**WILLIAMSON COUNTY, TEXAS**

CHANGE ORDER NUMBER: 7

Project: 09WC722A  
Roadway: RM 2338 Phase 2  
CSJ: 0211-01-023

Re: Change Order No. 07, CTSUD Water Line revisions

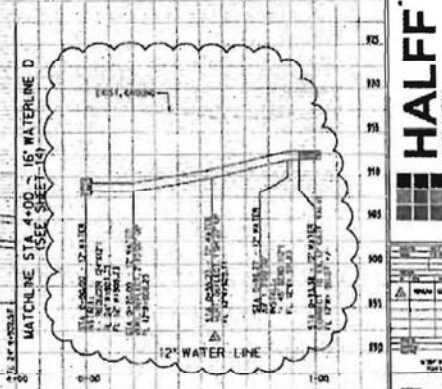
- The actual locations of existing waterlines in the vicinity of Ronald Reagan Blvd and CR 248 differed from the locations shown on the plans. Plan revisions (by CTSUD/Halff Associates) and quantity revisions were required to connect proposed waterline "A" to the existing waterlines on each side of the roadway.
- The layout of waterline "D" was revised to accommodate the future realignment of CR 245 at the intersection with RM 2338. These changes included additional encasement pipe and fittings.
